# AERONAUTICAL ACCESSORIES, INC.

## ALERT SERVICE BULLETIN

**ASB No. AA-07109**

- SUBJECT:** High Landing Gear Aft Crosstubes  
P/N 412-321-104 / 412-321-304
- MODELS AFFECTED:** Bell Helicopter Textron model 412, 412EP and 412CF and Agusta S.p.A. model AB412, AB412EP helicopters with Aeronautical Accessories, Inc. P/N 412-321-104 / 412-321-304 High Aft Crosstubes installed in accordance with STC SR01052AT.

**FIGURE 1 – CLEAR COAT AND INSPECTION AREA**

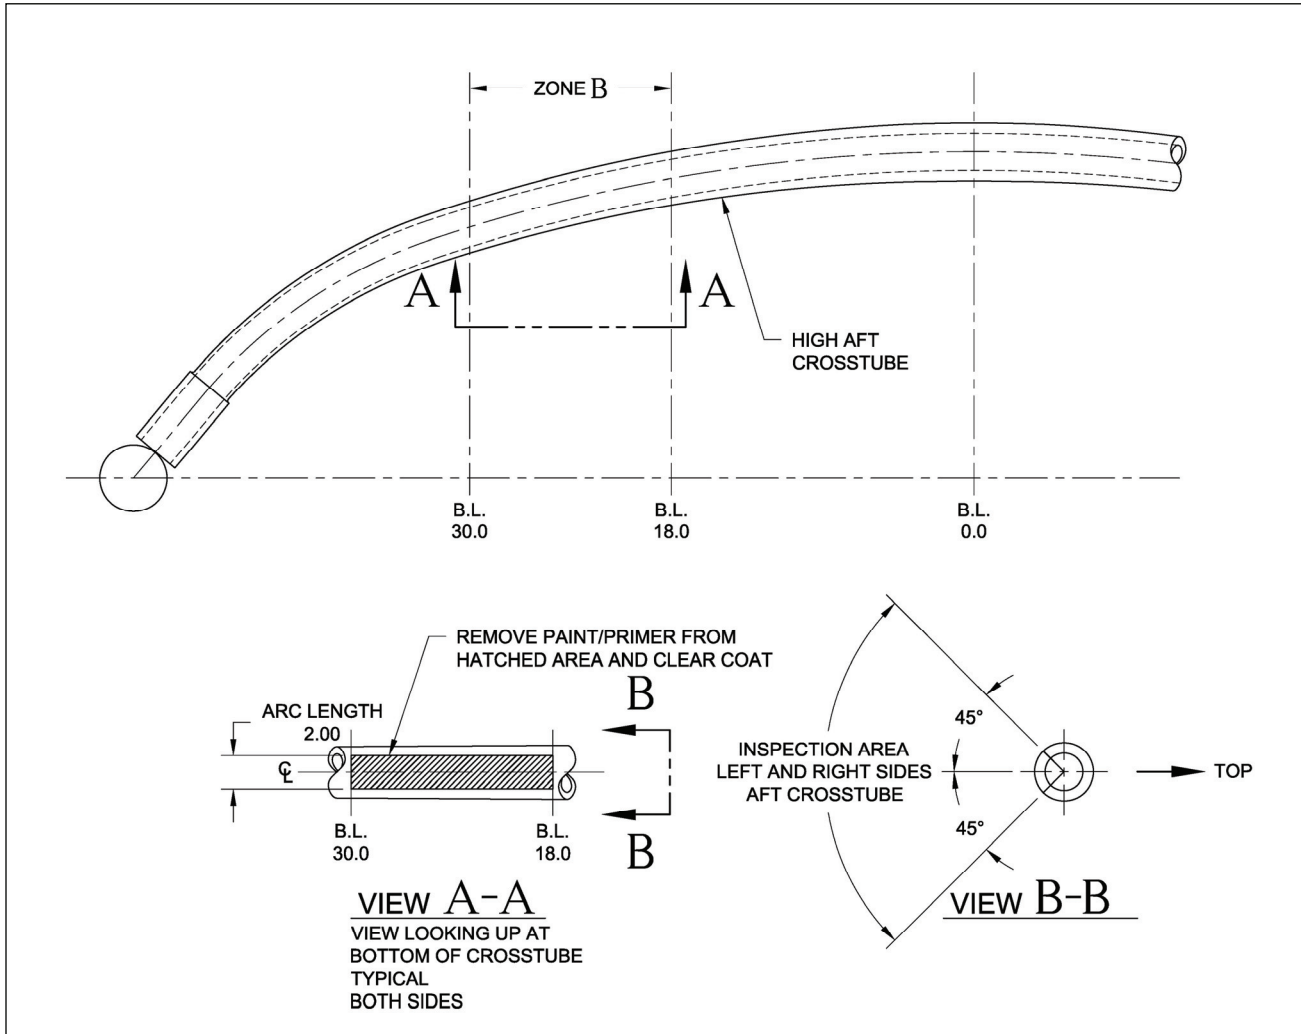
1. Prepare crosstube inspection areas by chemically removing crosstube paint and primer from an area  $2.0 \pm 0.25$  inches wide extending between BL 18 and BL 30 at the center-bottom surface of the crosstube on both the left and the right sides of the crosstube (see Figure 1).

1. Use MIL-PRF-87937 cleaning compound prepared in accordance with the manufacturer's recommendations to clean all residue and dirt from the cross tube surfaces shown in Figure 1.
2. Using at least 10X magnification and a strong light source, visually inspect the clear coated areas for indications of cracking.

2. Refinish crosstube by applying MIL-PRF-85582 primer and MIL-PRF-85285 paint (or equivalent) per manufacturer instructions to the stripped areas. The areas to be inspected per **Part B** should be masked to omit MIL-PRF-85285 paint as shown in Figure 1. Paint inspection areas with MIL-PRF-85285 Type I Gloss Clear coat as described in **Part B** of this bulletin.

**FIGURE 2 – HIGH LANDING GEAR DEFLECTION LIMITS**

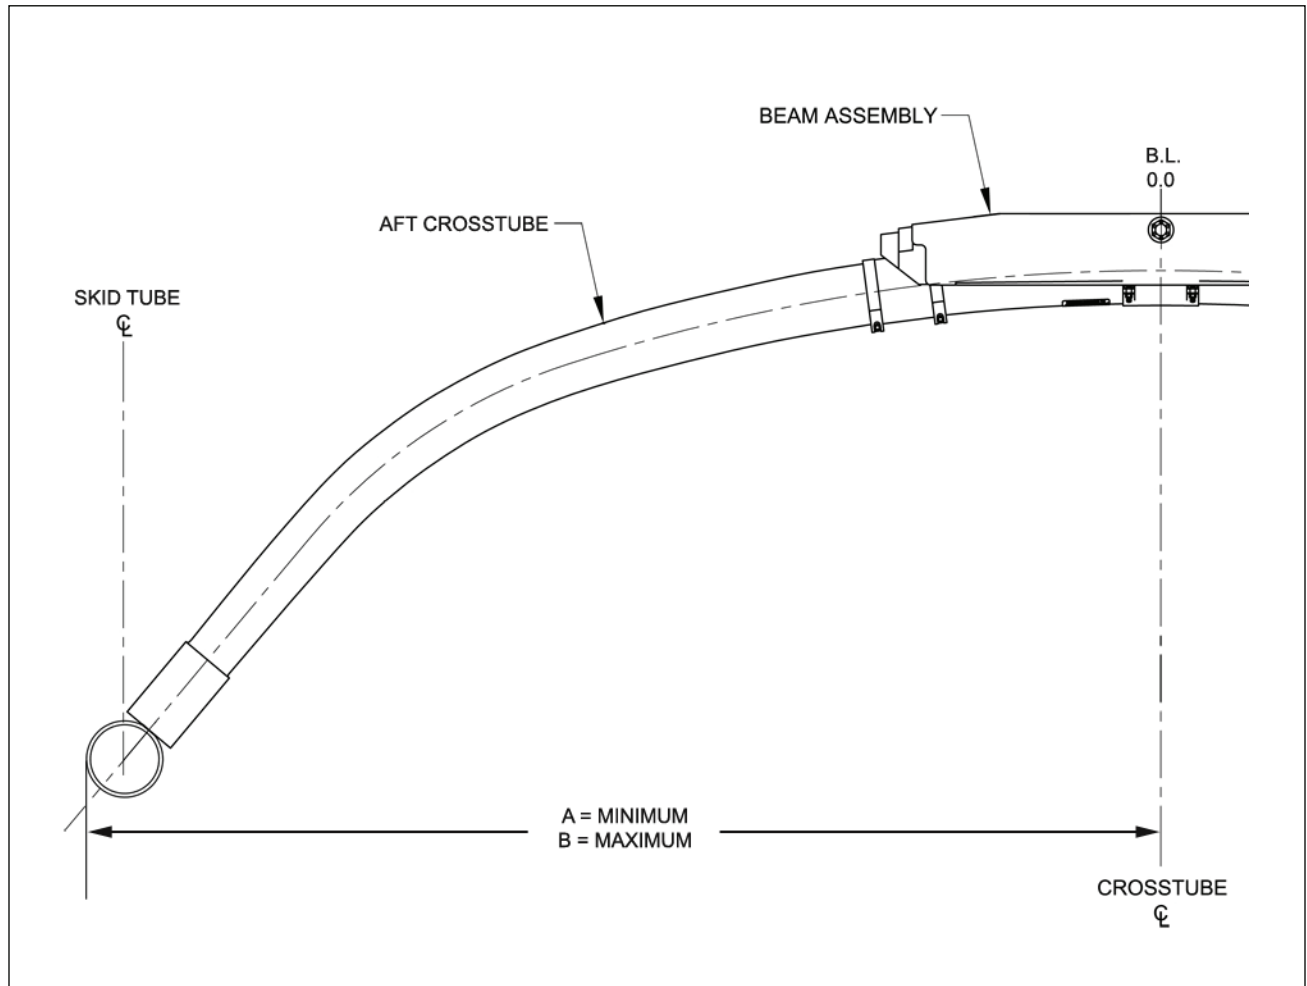
3. Measure the Crosstube horizontal deflection from the centerline of the helicopter, BL 0.00, to the outside of the skid tubes.
4. The Crosstube horizontal deflection as measured in step 3 above must be within the limits as shown in Figure 2. Crosstubes that measure outside of the limits must be replaced.

**FIGURE 3 – PAINT REMOVAL AREA**

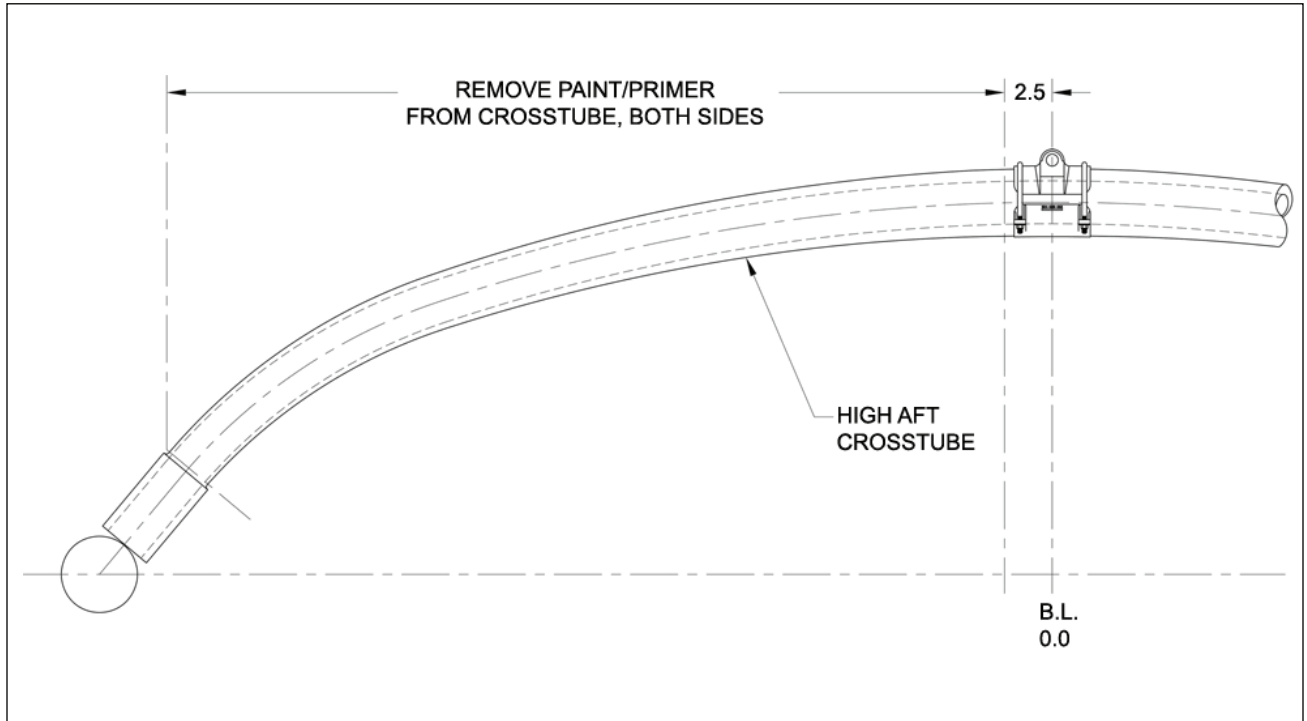
2. Prepare crosstube by chemically removing crosstube paint and primer outboard of the Upper Center Support to top of saddles. See Figure 3.
